GOBIND MARG CHARITABLE TRUST FOUNDATION

Revision to DP2024-02933 – Addition of Vestibule & Site Changes

ISSUED FOR DEVELOPMENT PERMIT
2026-10-16

8730 45th STREET N.E. CALGARY, ALBERTA

sheet title
Overall Site Plan

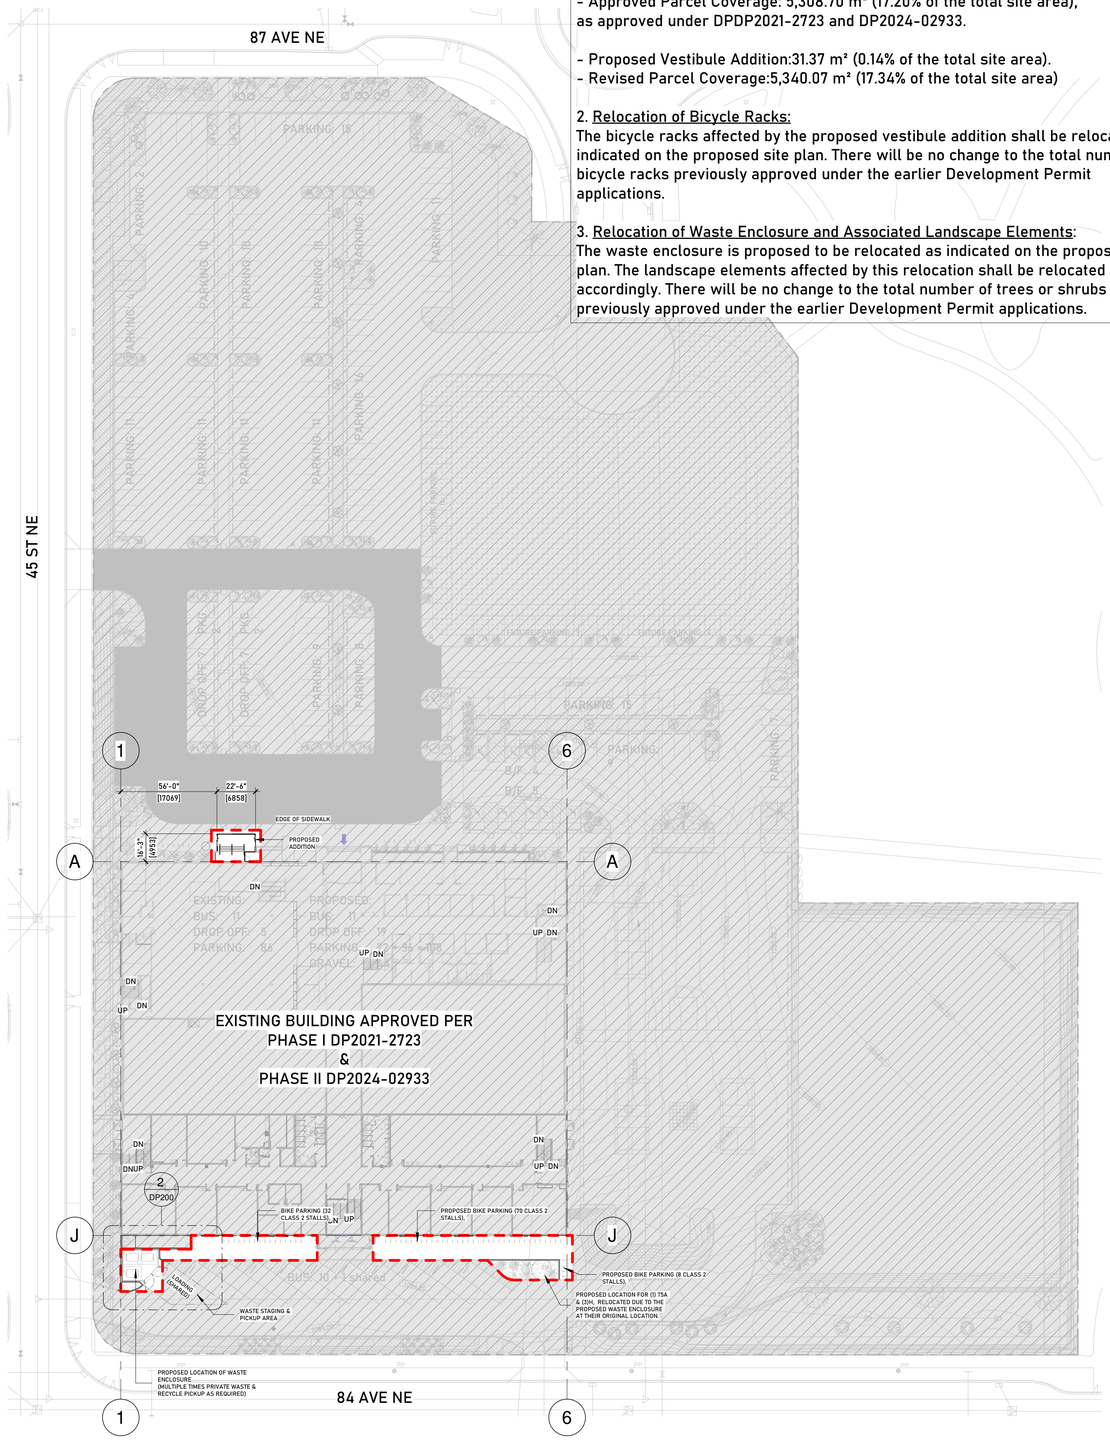
SCOPE OF DEVELOPMENT PERMIT (DP) APPLICATION:

1. Addition to Parcel Coverage:
Refer to the site data below for the proposed addition to parcel coverage:

- Approved Parcel Coverage: 5,308.70 m² (17.20% of the total site area), as approved under DPDP2021-2723 and DP2024-02933.

- Proposed Vestibule Addition:31.37 m² (0.14% of the total site area).
- Revised Parcel Coverage:5,340.07 m² (17.34% of the total site area)

2. Relocation of Bicycle Racks:
The bicycle racks affected by the proposed vestibule addition shall be relocated as indicated on the proposed site plan. There will be no change to the total number of bicycle racks previously approved under the earlier Development Permit applications.

3. Relocation of Waste Enclosure and Associated Landscape Elements:
The waste enclosure is proposed to be relocated as indicated on the proposed site plan. The landscape elements affected by this relocation shall be relocated accordingly. There will be no change to the total number of trees or shrubs previously approved under the earlier Development Permit applications.
